Re: CLARIFICATION OF FURTHER INFORMATION RESPONSE

**Planning application for Electric fast charging hub and drive-thru coffee building (24/7 opening hours). 8 electric fast charging spaces to the west side of the site; drive-thru coffee building (167sqm) will contain a beverage area, seating area and back of house area (storage, lobby, toilets); single storey building with a maximum ridge height of 6m and a minimum ridge height of 3.6m; 3 signs on the building; ancillary development of refuse compound, 4 free standing signs, 1 free standing height restrictor, 1 substation(28.75sqm 3.075m high), 31 car parking spaces, internal vehicular access, internal circulation road, paving, pedestrian entrance with steps, landscaping, boundary treatment and all associated site works including pumping station. 13 existing car park spaces will be removed to facilitate the proposed at Applegreen, Naas Road Service Station, Tootenhill, Rathcoole, Dublin, D24DH00

Reg. Ref. SD22A/0114**

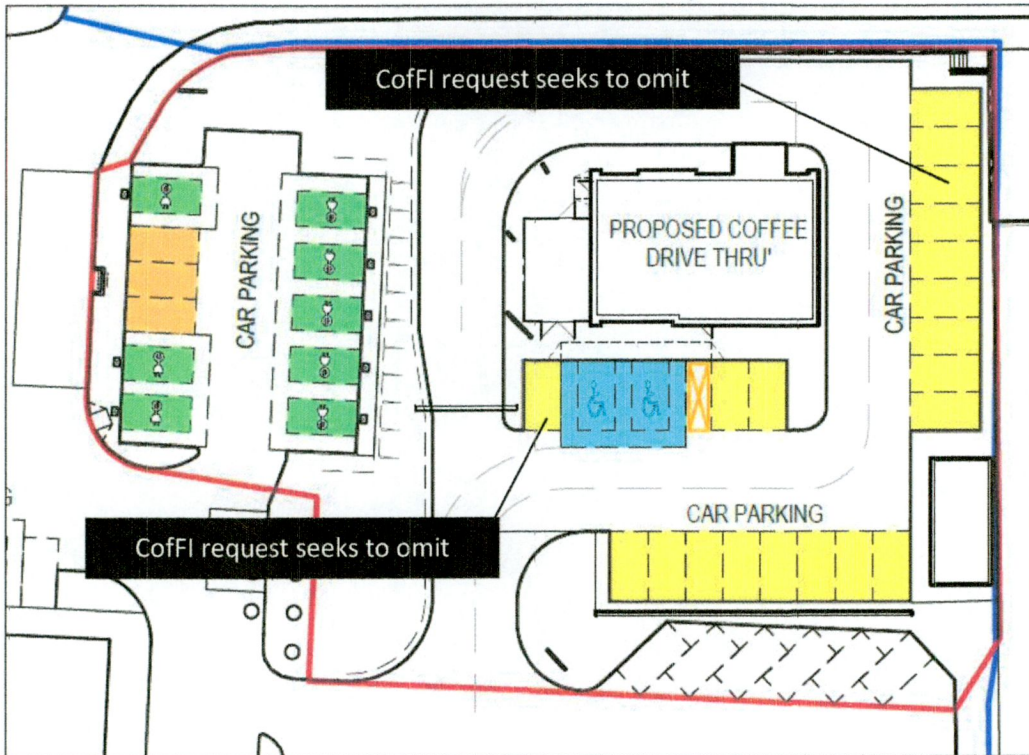
*1. From the plans submitted, it appears that the applicant is proposing to provide 22 no. car parking spaces to serve the coffee shop. This is significantly in excess of the maximum standard permissible in the Development Plan. The applicant is requested to submit a **revised car parking layout removing excess parking spaces**, indicated above the maximum permissible rates per Table 12.25 of the Development Plan 2022 – 2028. **The 9 no. car parking spaces along the eastern boundary shall be removed and replaced by enhanced landscaping and SuDS proposals. In addition, the 1no. car parking space to the left of the mobility bays serving the coffee shop, and in front of the refuse area, shall also be removed.** In providing a revised landscaping and SuDS strategy, the applicant should also have regard to the sites location within a Riparian Corridor, referenced in Chapter 4 and Section 12.4.3 of the Development Plan 2022 - 2028.*

Please refer to the **revised site layout drawing** prepared by JA Gorman Consulting Engineers and the **car parking schedule** below.

A total of 11 car park spaces are provided for the drive-thru coffee facility – 9 no. general spaces and 2 no. disabled spaces.
